SB-79-82

FINAL
ENVIRONMENTAL IMPACT REPORT
CABRILLO PLAZA SPECIFIC PLAN

MAY 1983

CERTIFIED
April 29, 1983

PROJECT TRIP DISTRIBUTION
 WITHOUT WR2M FREEWAY

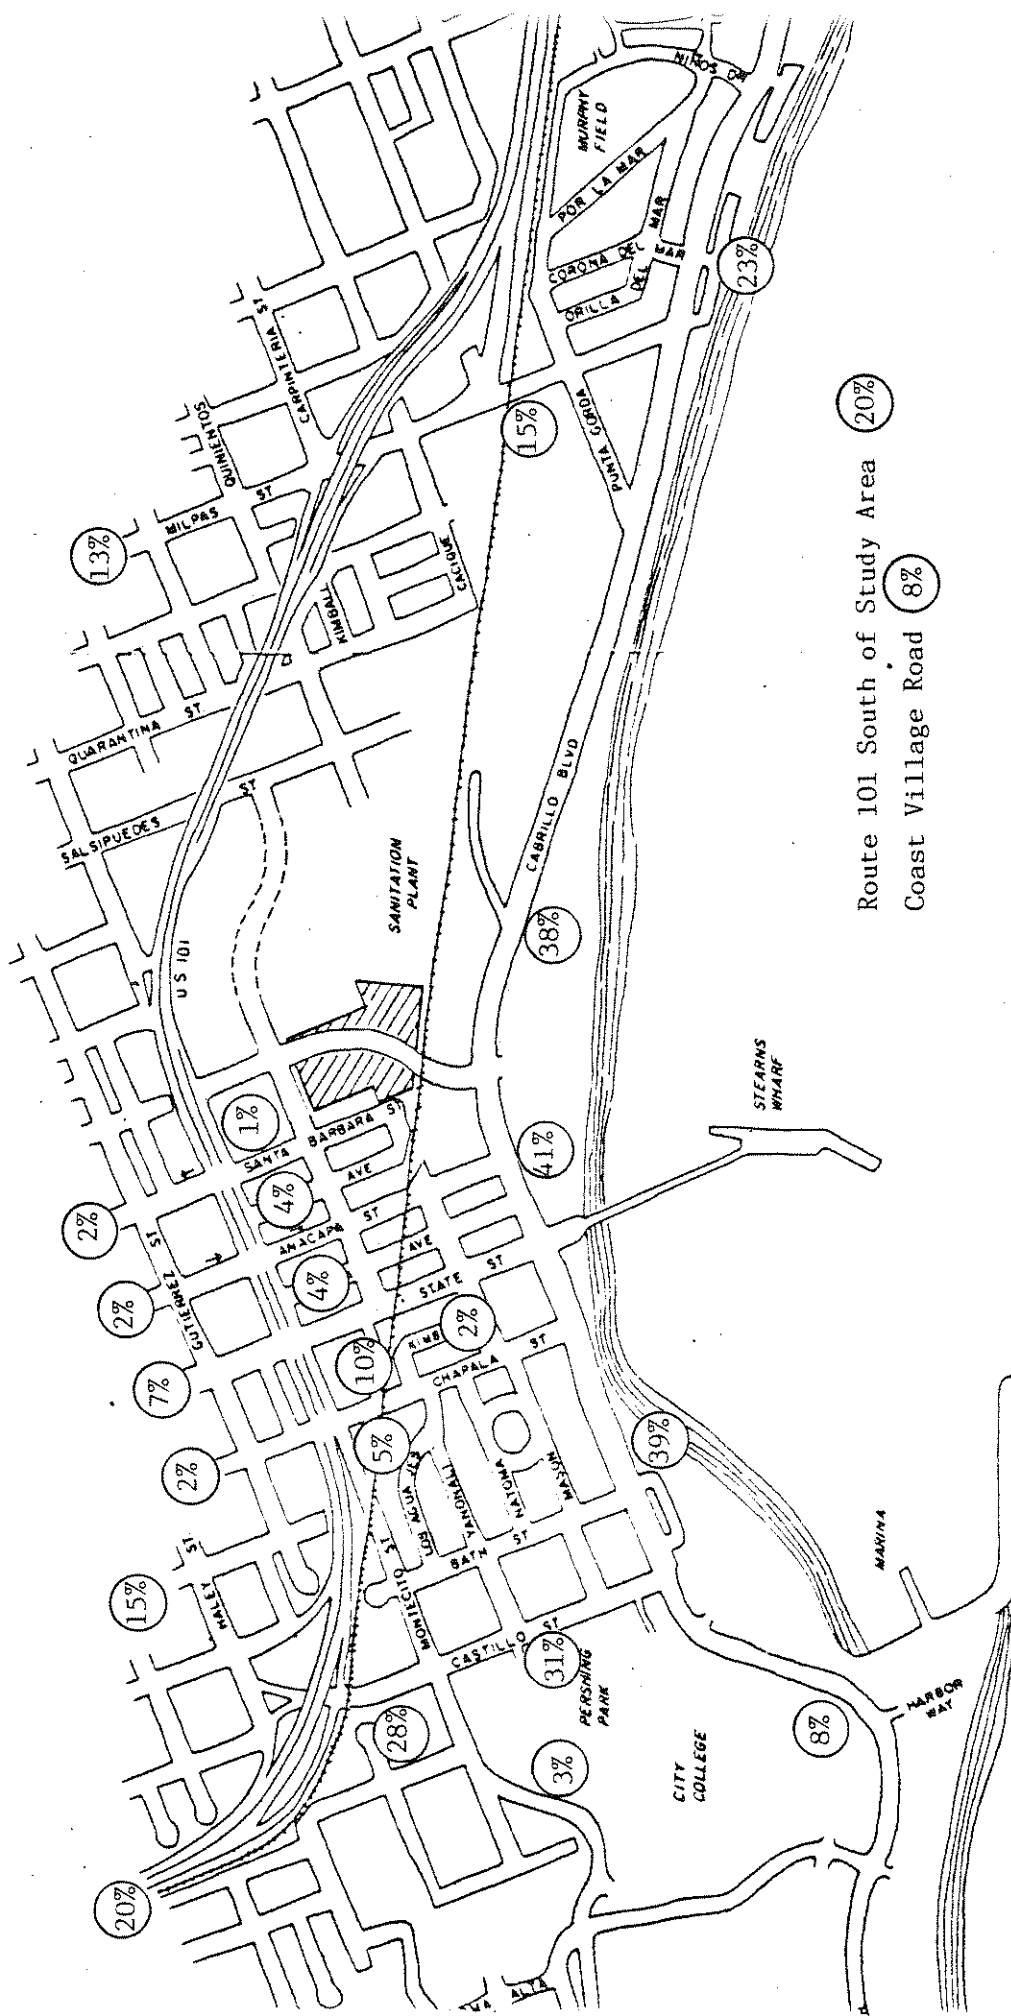
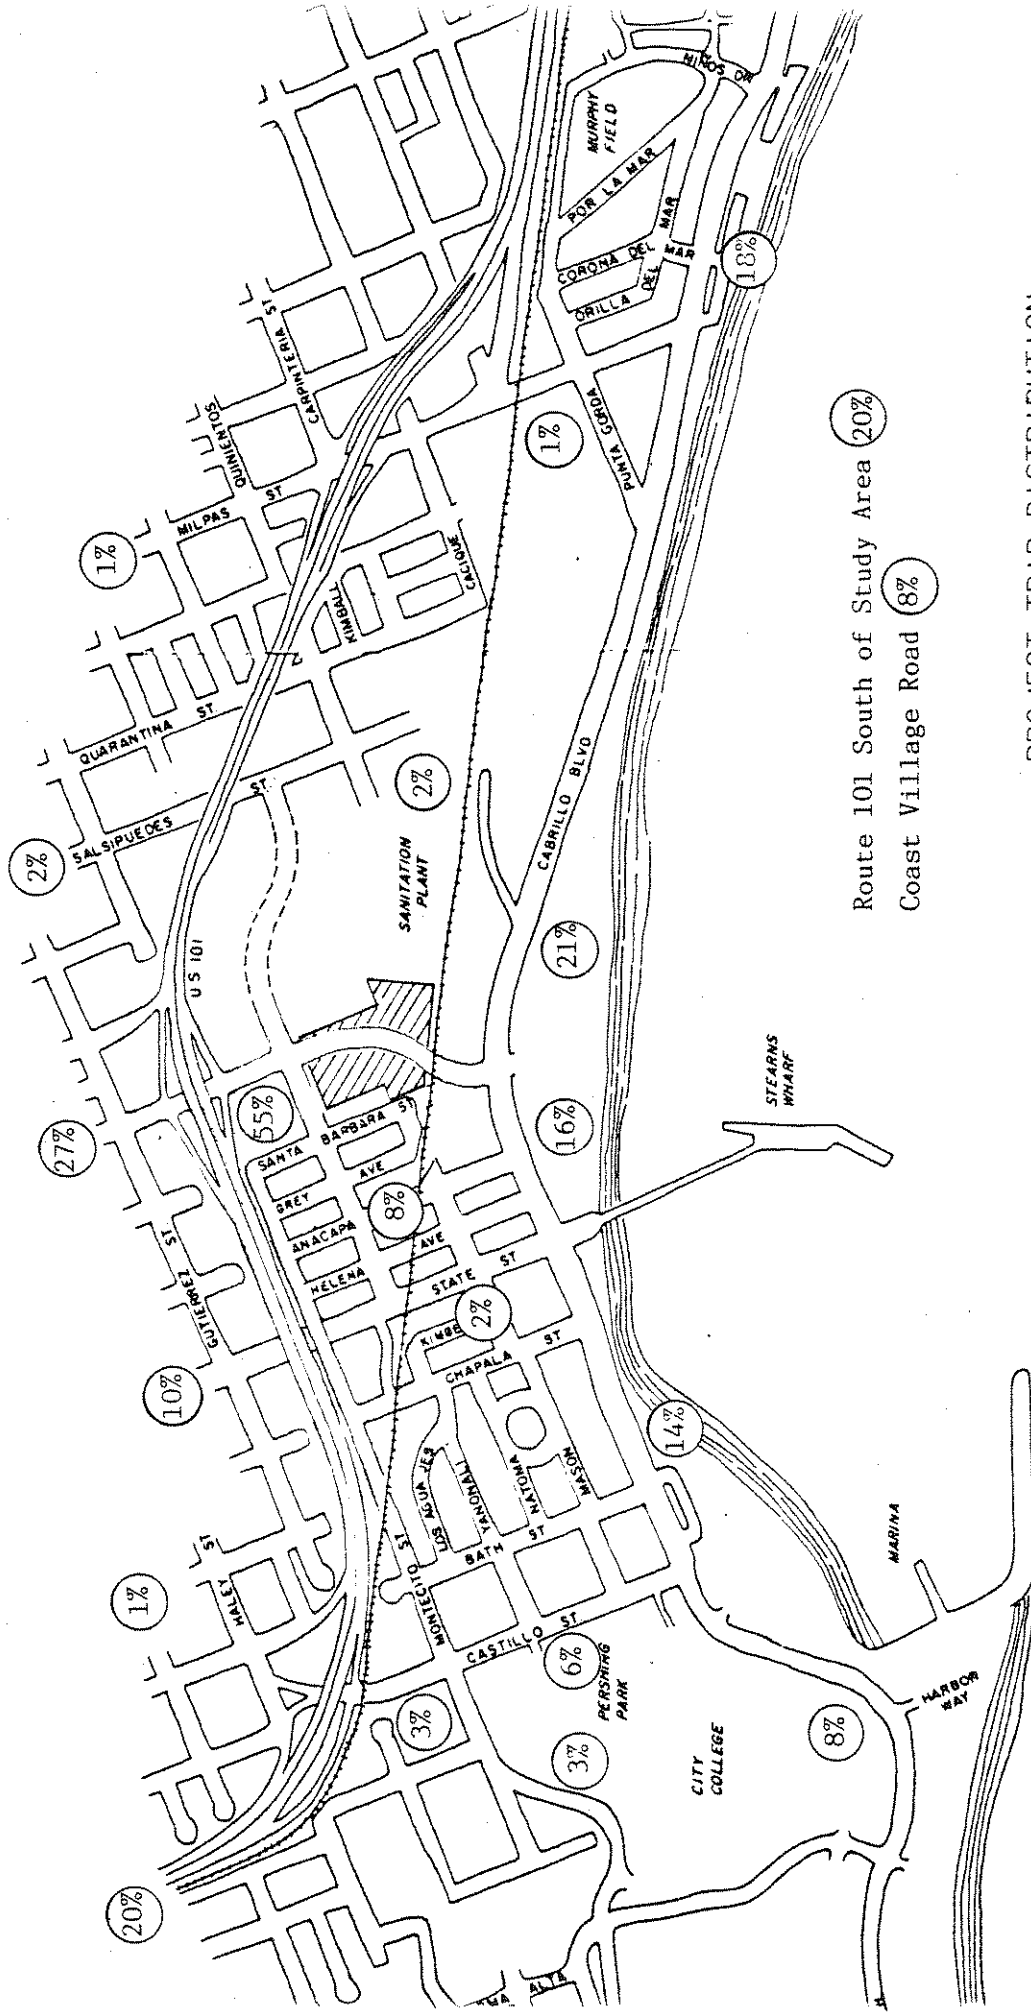
We are skeptical as to the accuracy of the information regarding trip distribution. This is particularly true for traffic in the immediate vicinity of the project site. Unless we are mistaken, the conclusions presented in Figures 11 and 12, on page 36, reflect a linear shift in traffic from Anacapa/Santa Barbara to Garden when the freeway plan SGRN is completed. This is the only change indicated (with exception of the 2.5% traffic flow on State Street which is missing from Figure 11). On the following page, however, we are presented a host of volume projections which indicate substantial changes in traffic flow. Finally, the report contains Table 8, a traffic volume summary which does not correlate with either of the previous pages. To complicate matters, an extrapolation of the data in Appendix C, Page 83, results in our conclusion that a fourth set of distribution data must have been used to calculate level of service.

The project trip distribution should be explained in greater detail. Also, the distribution percentages shown in Figures 11 and 12 appear to be different from those recommended in WATS Table VI-4. This difference should be explained or the percentages revised to conform to WATS. The same comments made about Figure 7 apply to Figure 13 and 14.

PROJECT SUMMER SUNDAY TRAFFIC
 VOLUMES WITHOUT WR2M FREEWAY

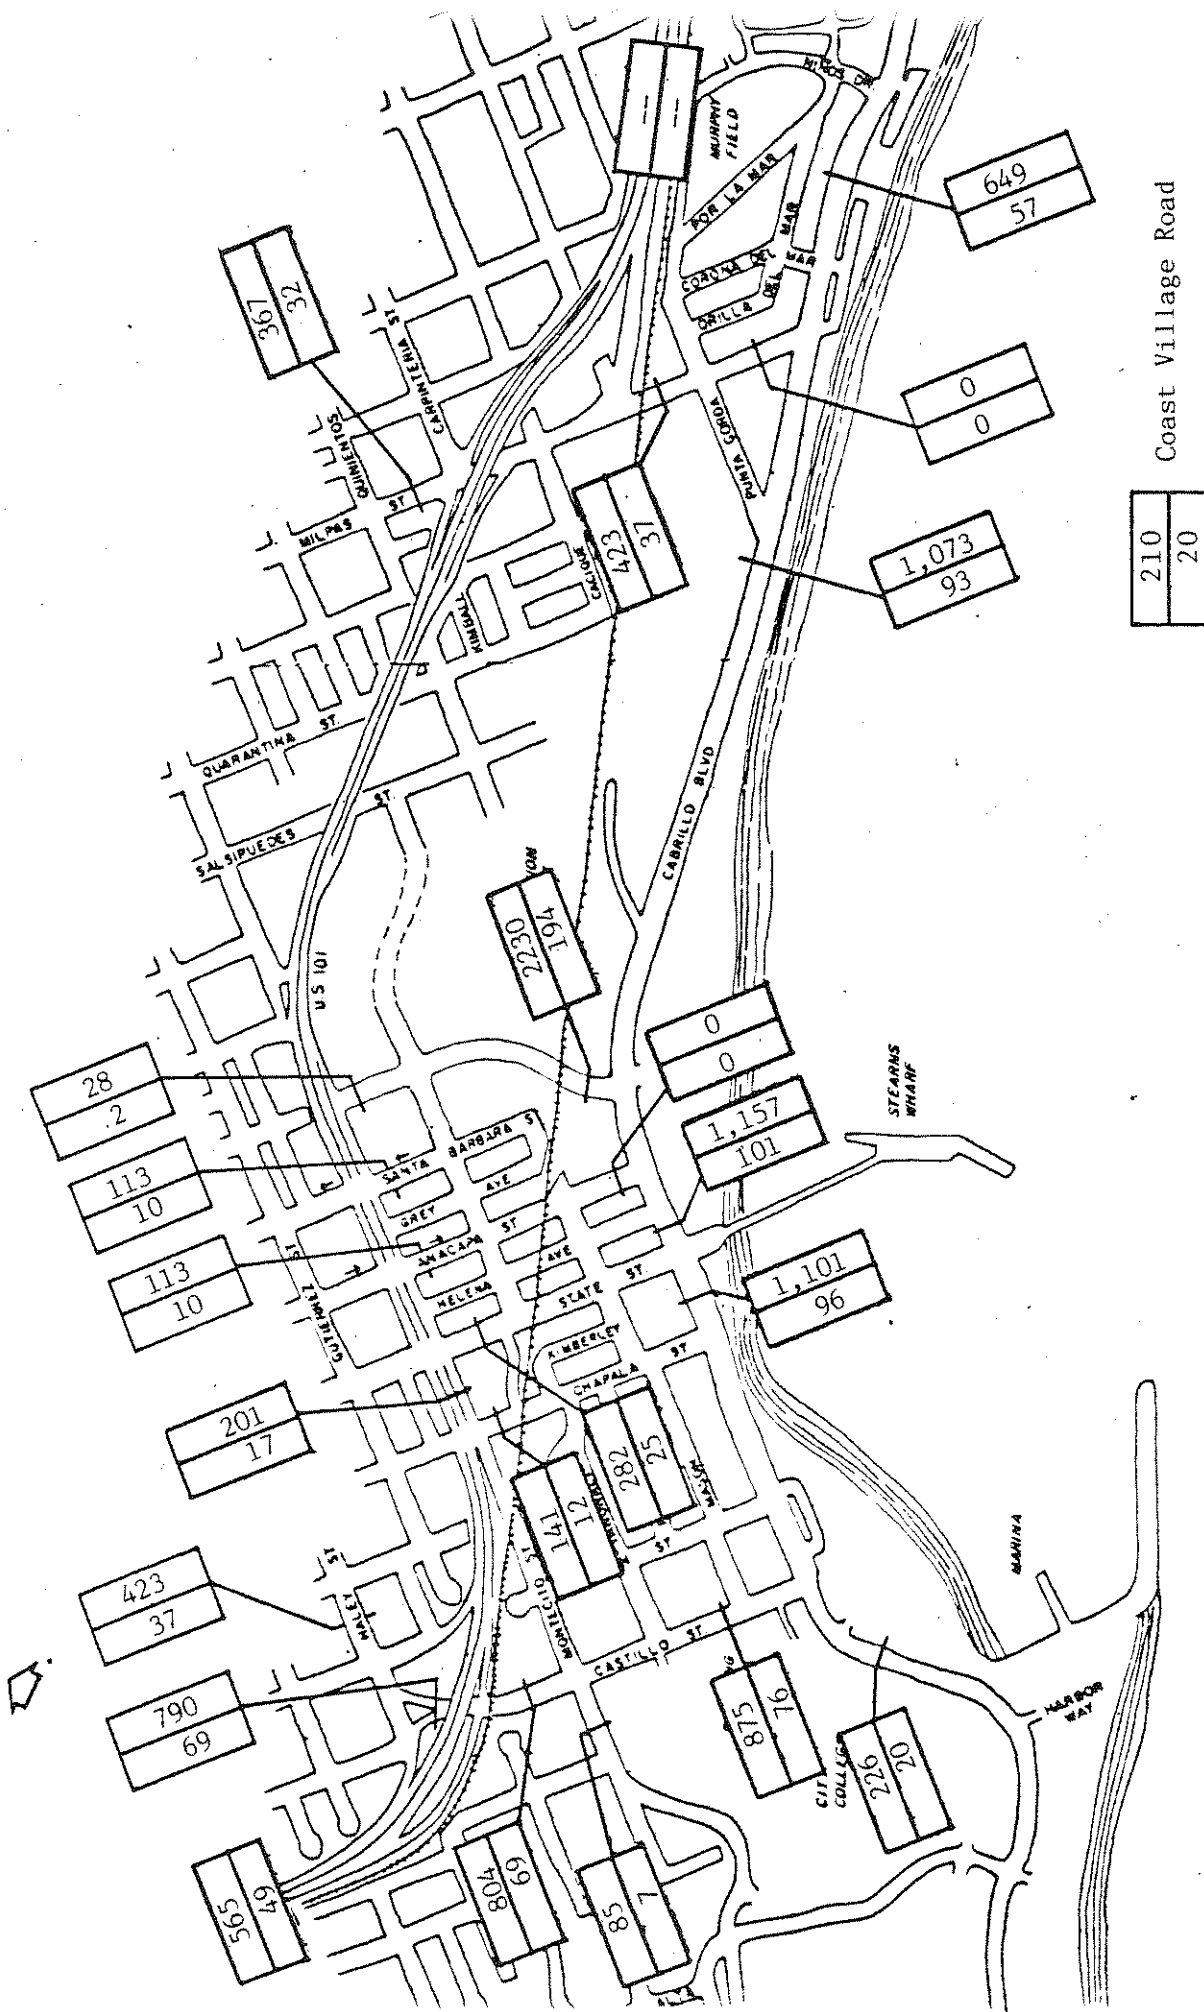
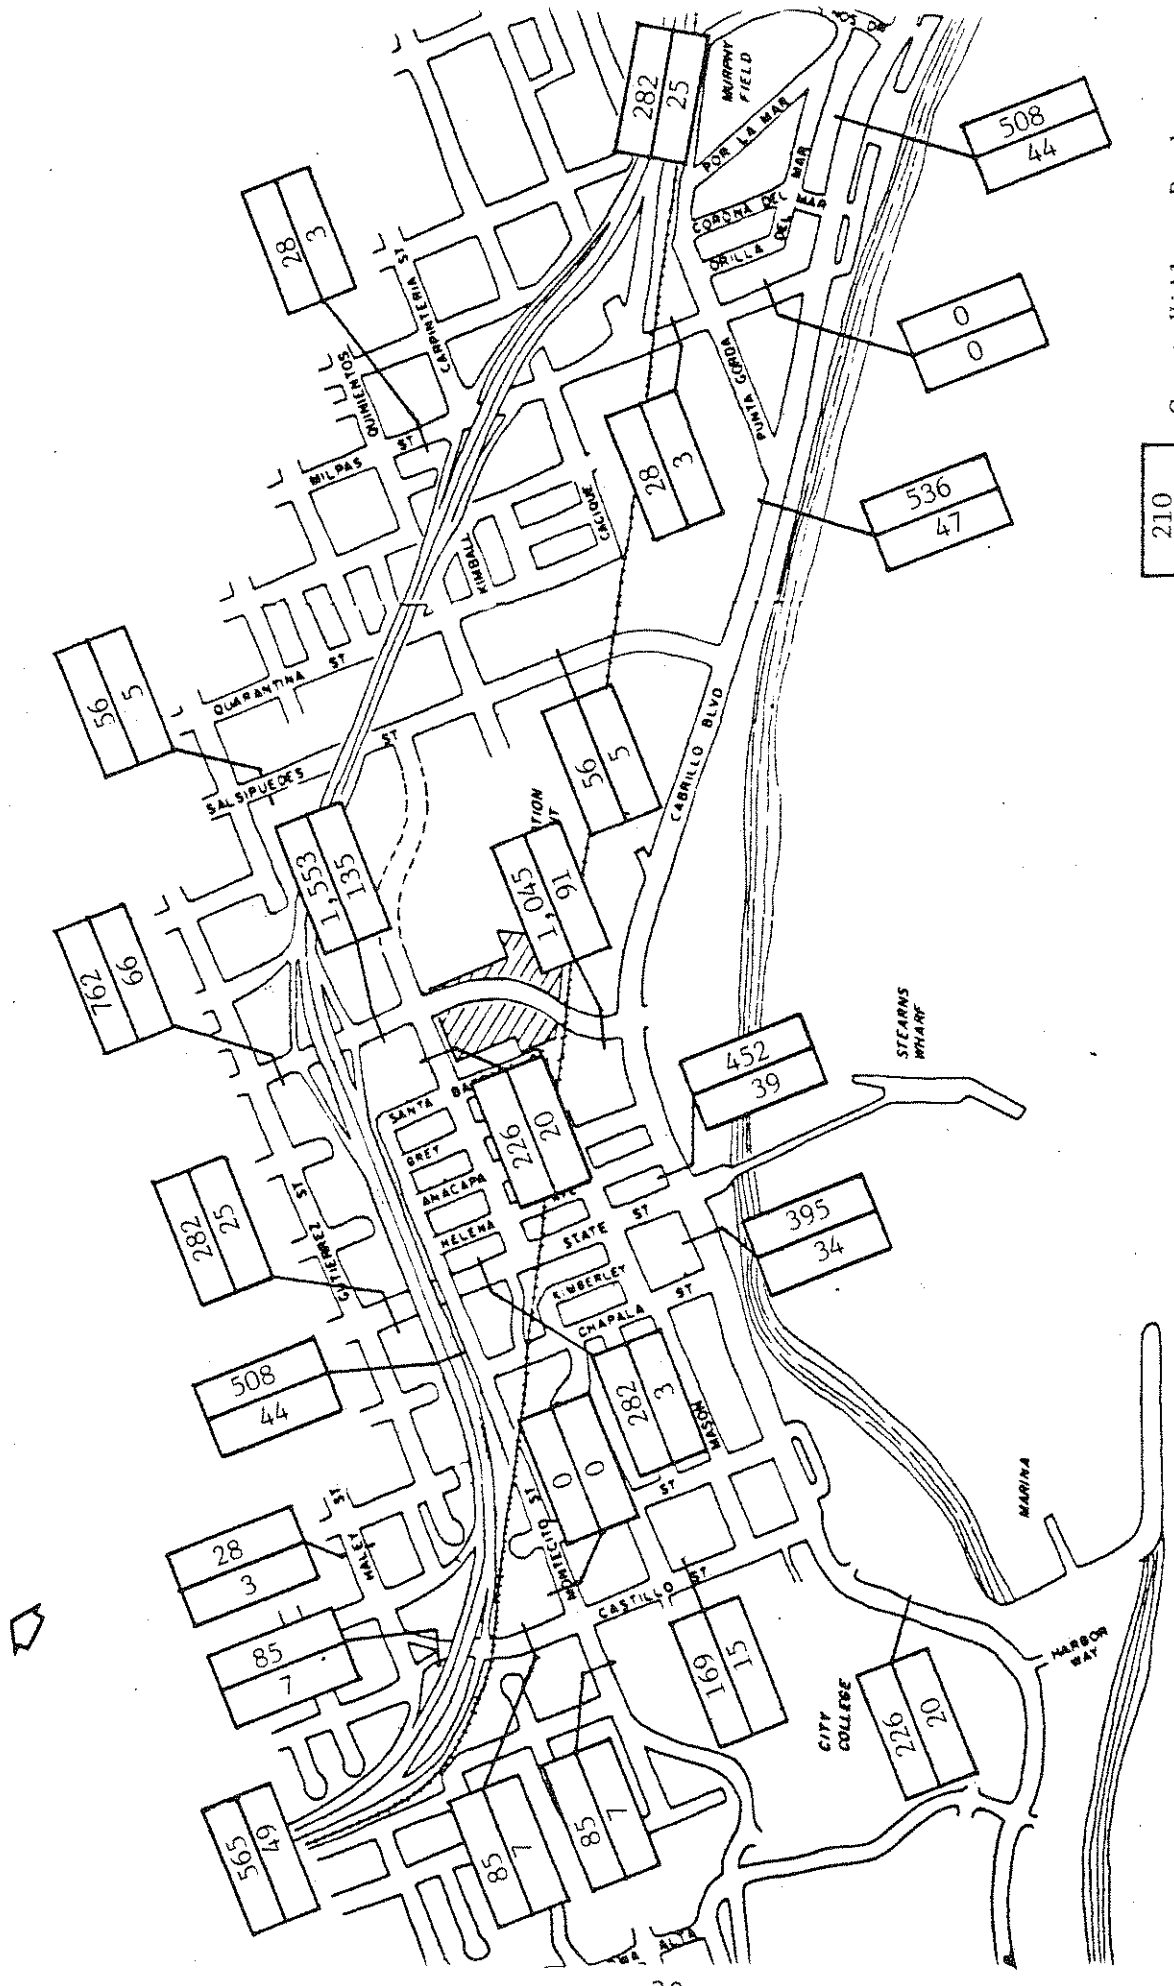
In Figures 13 and 14, traffic generated north of the freeway is not considered. This traffic will be loaded on the Garden Street Interchange. With the change in traffic pattern, a new traffic distribution and level of service analysis is necessary. The potential intensification of the carbon monoxide hotspot at Garden needs evaluation.
